Access Compliance Report Public Rights-of-Way (Curb Ramps)

Main Street: TIFFANY_PL Cross Street: BRITTANY_WOODS_DR Location: SW

ADA ID: RPRK211014154355 Ramp Type: Type 4 - Parallel Initial Pass/Fail: Fail Overall Compliance: No Severity Score: 16

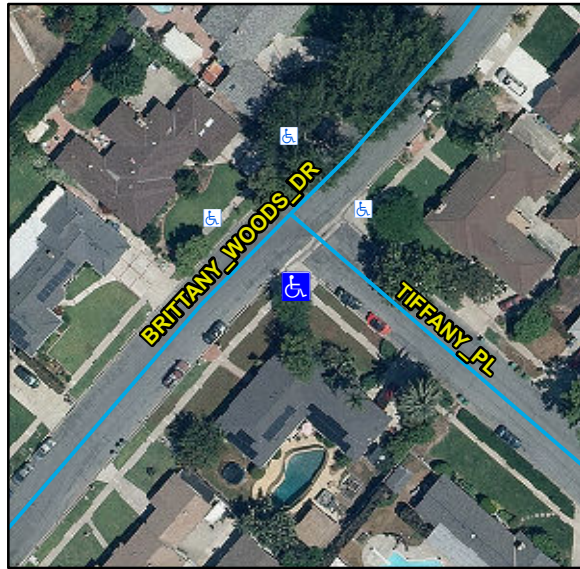
Compliance	Description	Data	Compliance	Description	Data
N/A	Ramp Length LT (in)	165	N/A	Ramp Length RT (in)	165
Yes	Ramp Width LT (in)	100	Yes	Ramp Width RT (in)	98
No	Ramp Run Slope LT (%)	8.9	Yes	Ramp Run Slope RT (%)	6.9
No	Ramp Cross Slope LT (%)	3.4	No	Ramp Cross Slope RT (%)	4.9
N/A	Landing Present	N/A	N/A	DWS Provided	N/A
N/A	Landing Length (in)	N/A	N/A	DWS Contrast	N/A
N/A	Landing Width (in)	N/A	N/A	DWS Length (in)	N/A
N/A	Landing Run Slope (%)	N/A	N/A	DWS Full Width	N/A
N/A	Landing Cross Slope (%)	N/A		DWS Offset Type	N/A
N/A	Landing Movement Obstructed?	N/A	N/A	DWS Offset Left (in)	N/A
	Landing Movement Type	N/A	N/A	DWS Offset Right (in)	N/A
N/A	Landing Shared	N/A			
N/A	Clear Space	Yes			
N/A	Clear Space To Crosswalk (in)	N/A			
N/A	Marked Crosswalk 1	No	N/A	Marked Crosswalk 2	No
	Crossing 1 Direction	NE		Crossing 2 Direction	NW
N/A	Marked Crosswalk 1 Width (in)	N/A		Marked Crosswalk 2 Width (in)	N/A

Remove & Replace Curb Ramp With Two New Directional Ramps or Equivalent.
